HUNTS GROVE
GLOUCESTERSHIRE

Section 73 Planning Application

ADDENDUM TO THE DESIGN & ACCESS STATEMENT

June 2015

CHARACTER AREAS PLAN

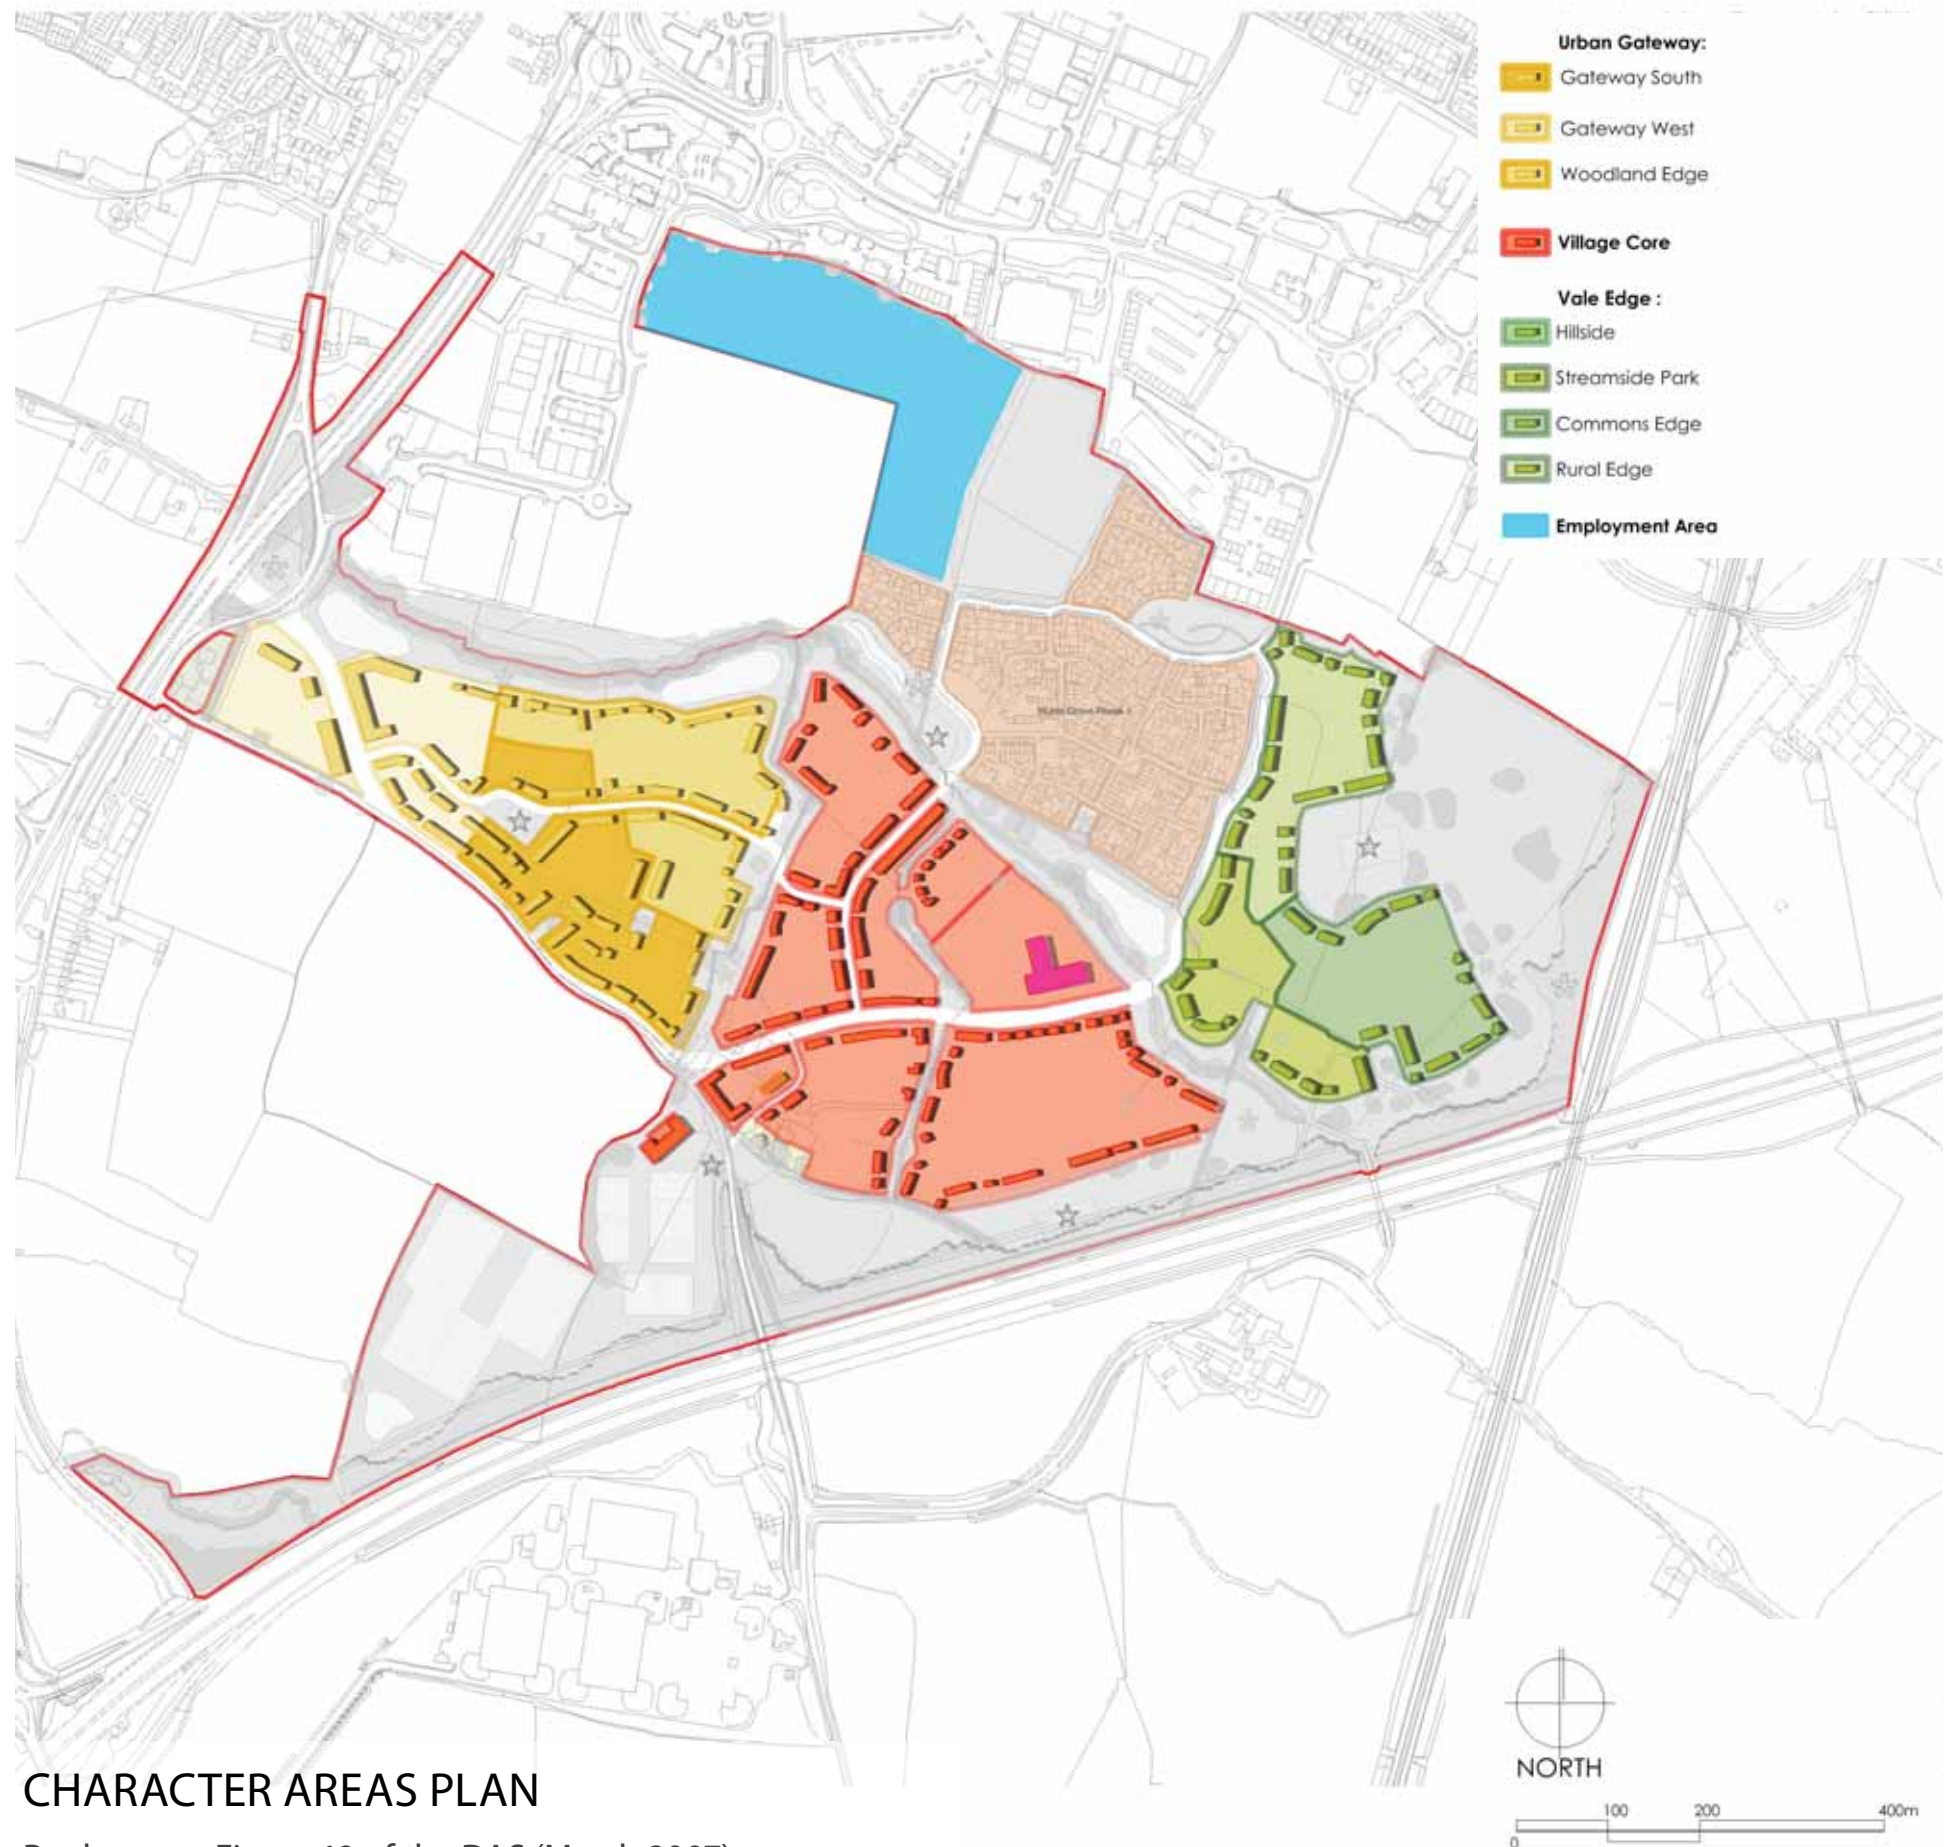
Key Change

- *Repositioning of the neighbourhood centre area to the western entrance.*

ACCESS & CIRCULATION PLAN (SUPPLEMENTAL ES FIGURE 2.4)

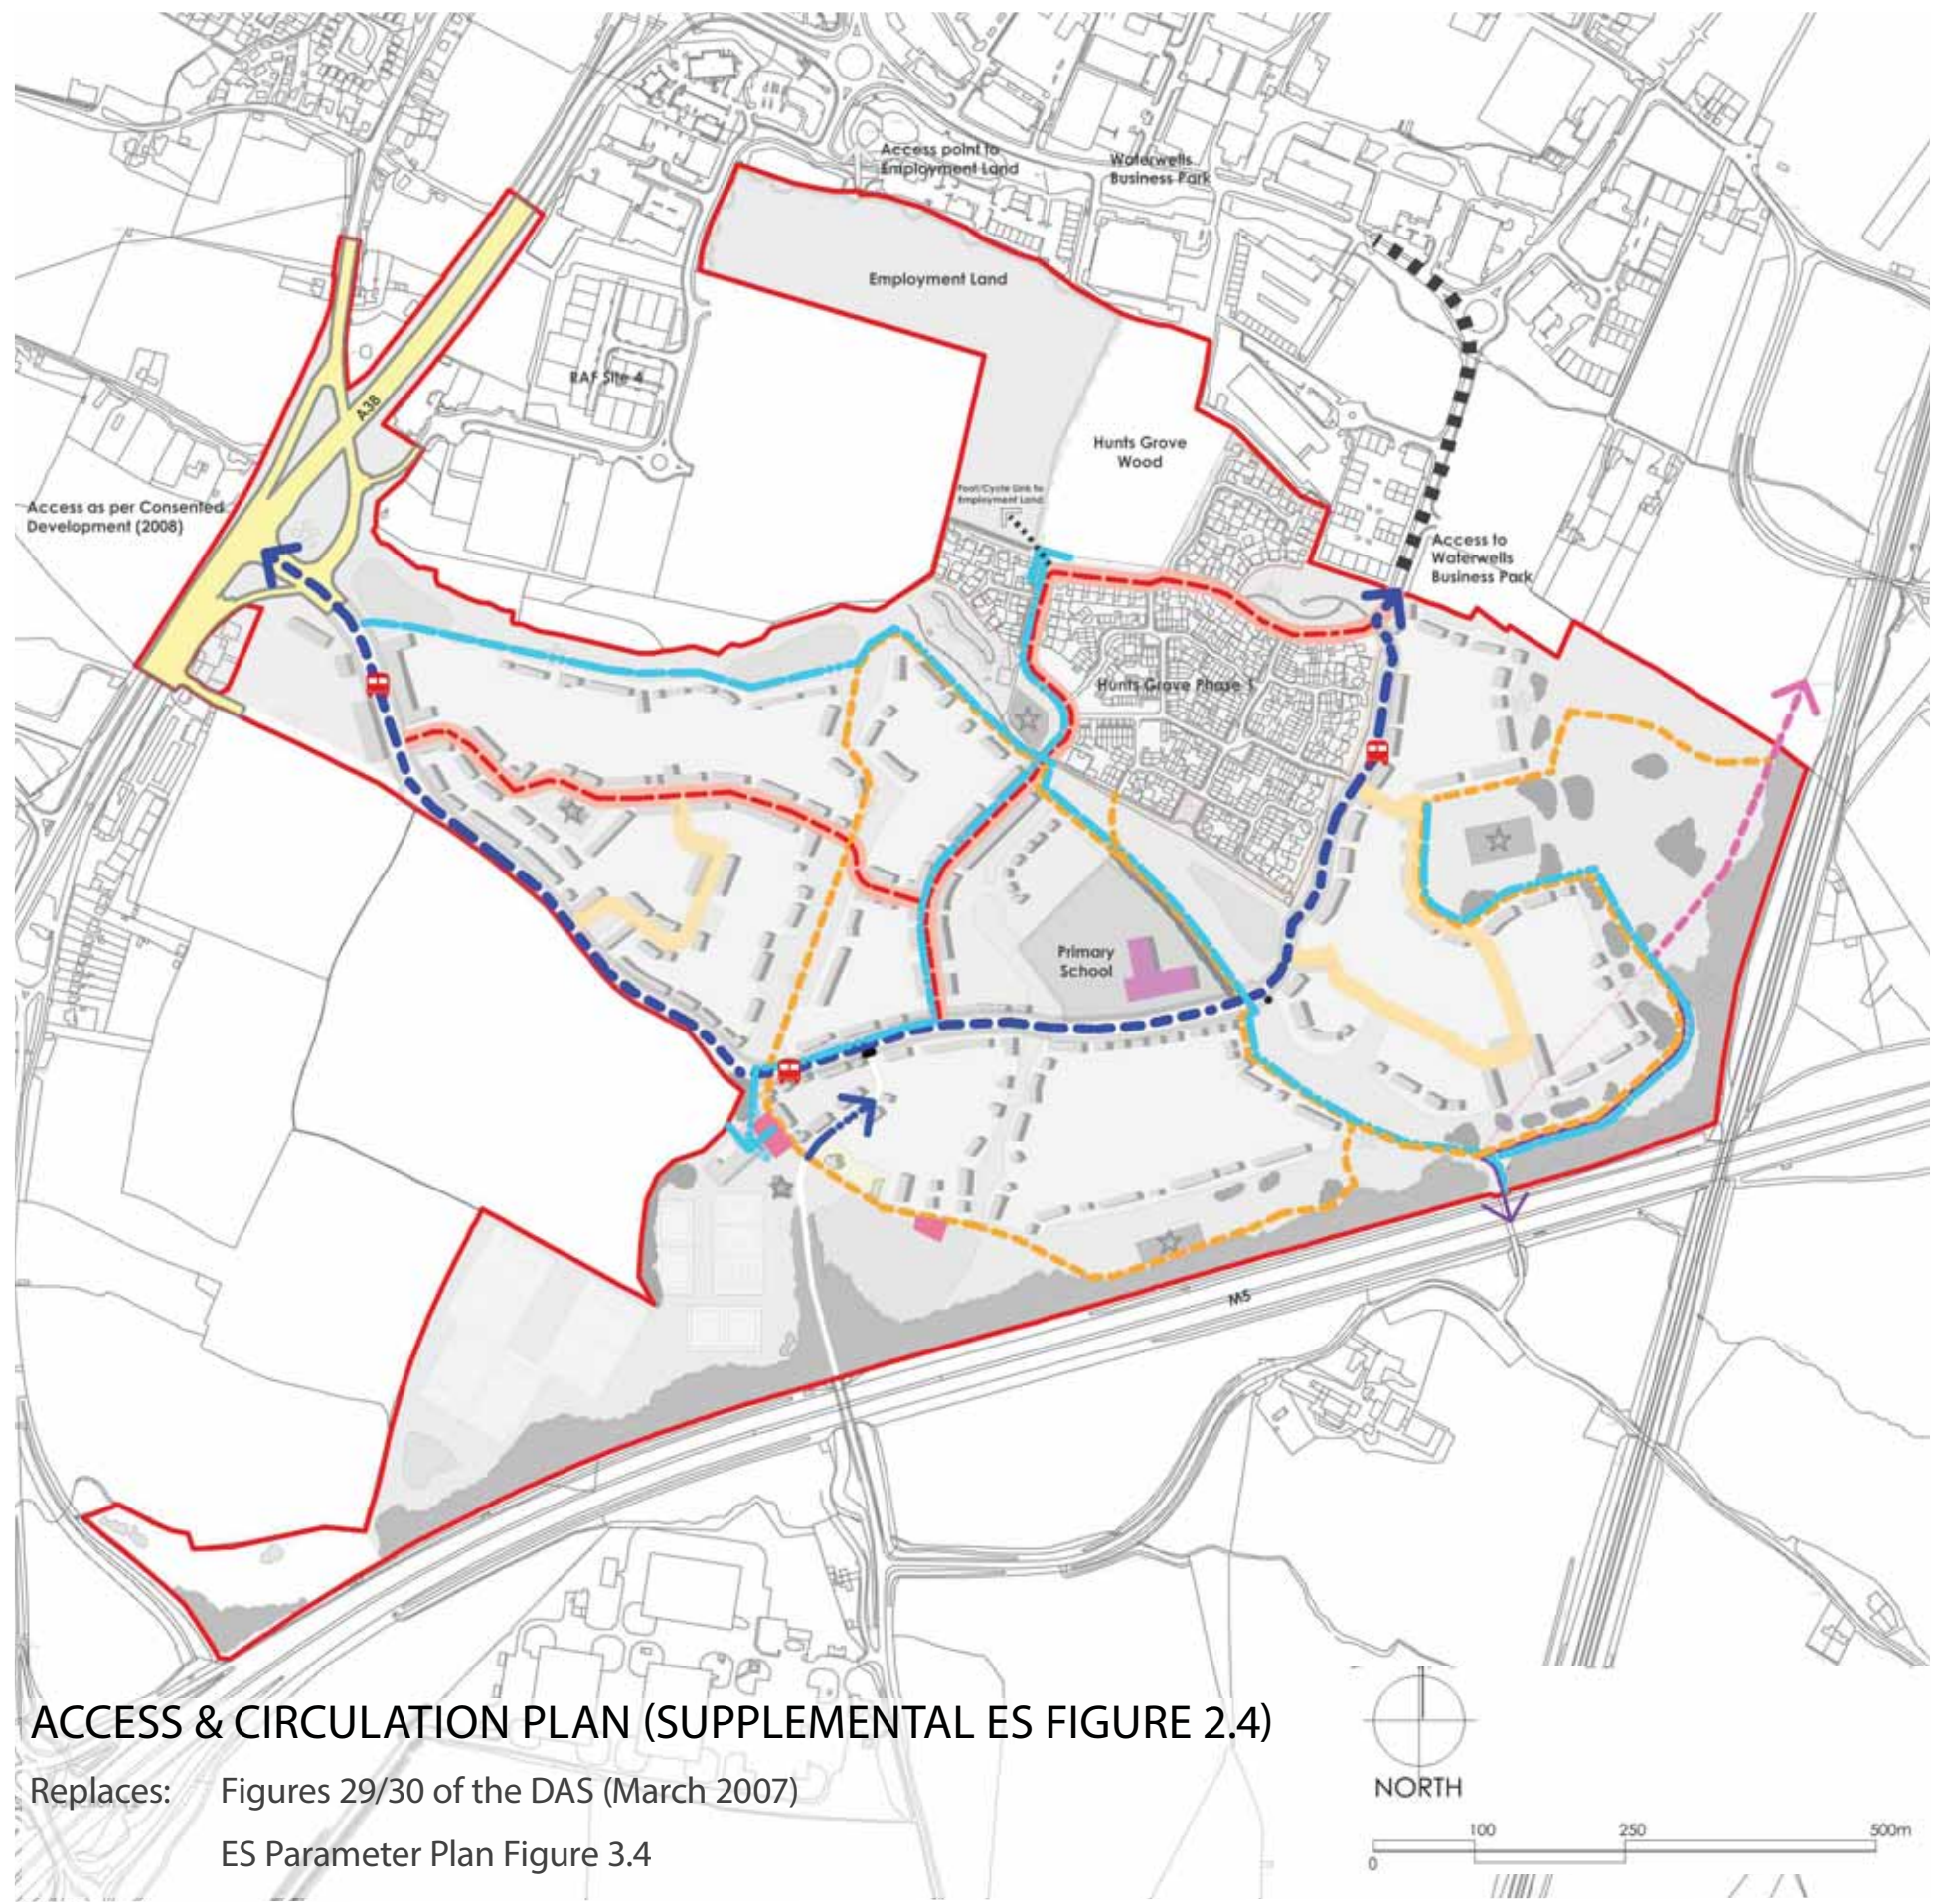
Key Changes

- Amendment to widen and utilise Haresfield Lane as the primary route through the development, including operating as a bus route
- Partial closure of Haresfield Lane to through traffic to the western end
- Provision of a one way connection from the southern end of Haresfield Lane into the development
- Amendment to the phasing of the A38 Junction to allow an increase in the quantum of development utilising the existing Waterwells access prior to implementation of the A38 Junction
- Relocation of the small car park from the northern end of the allotments to a proposed location to the south east

STREET STRUCTURE

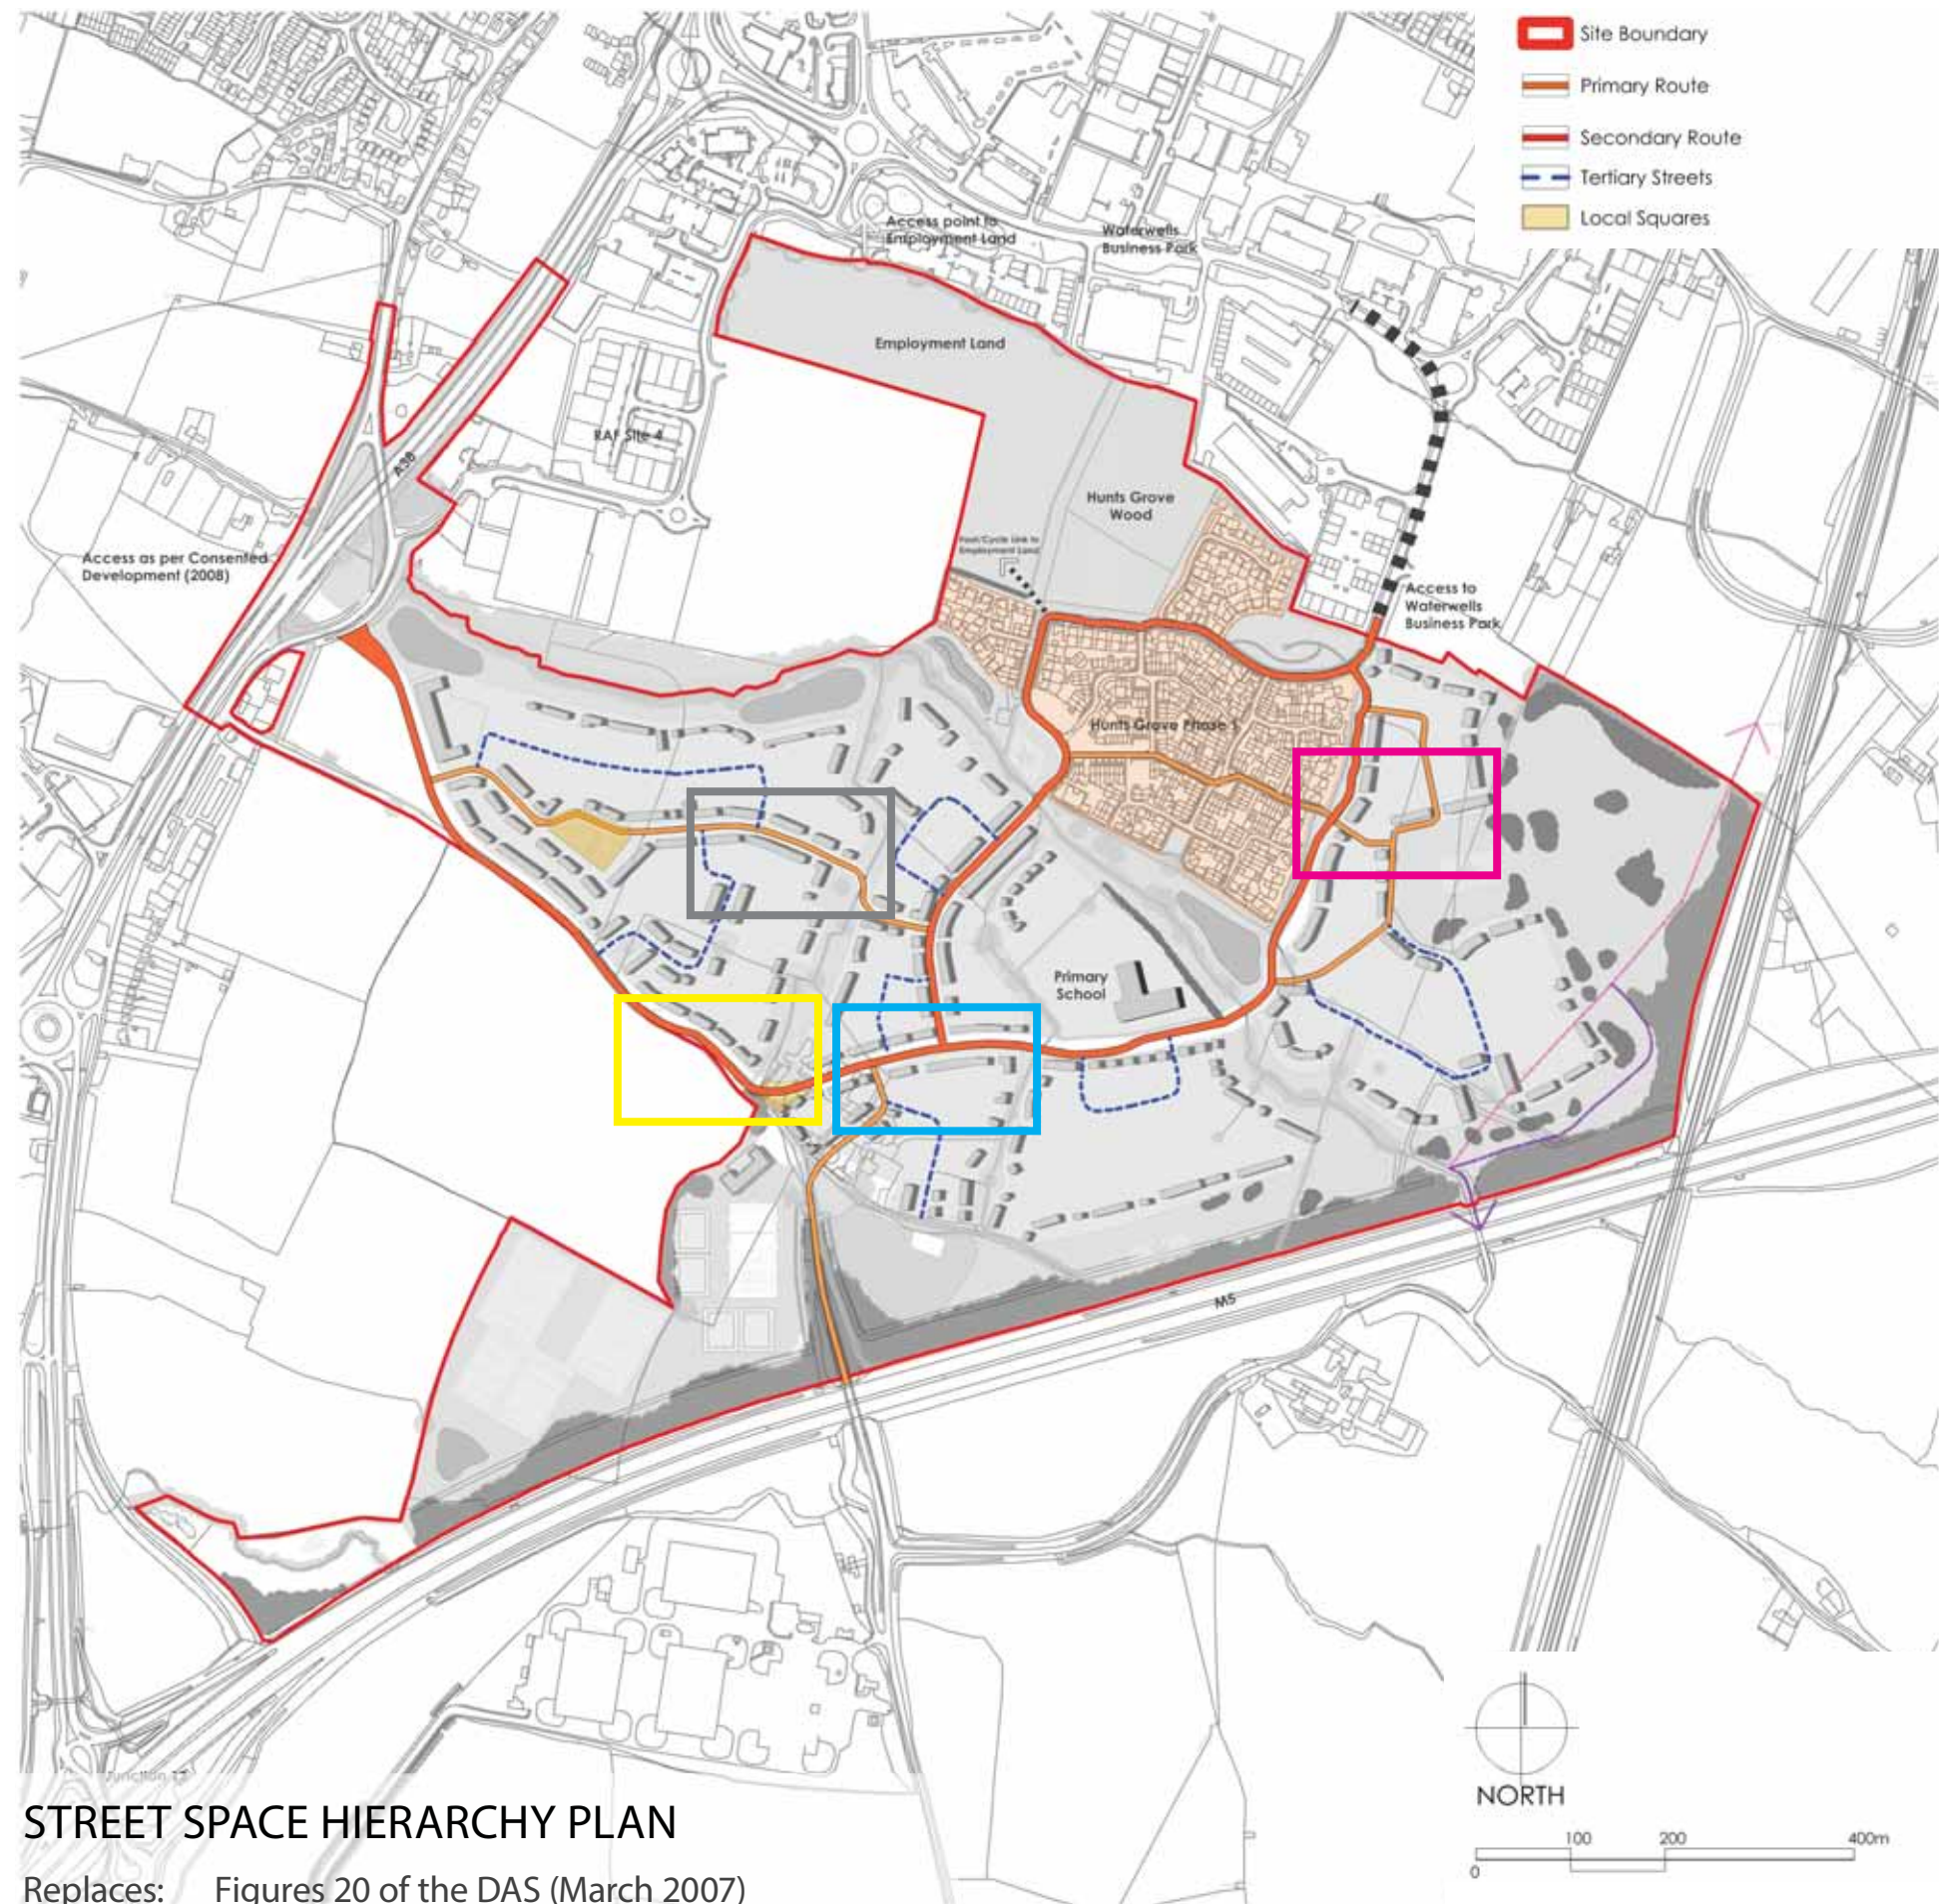
Key Changes

- Primary route to include section of Haresfield Lane
- Reduction in the size and number of squares to ensure a more efficient layout
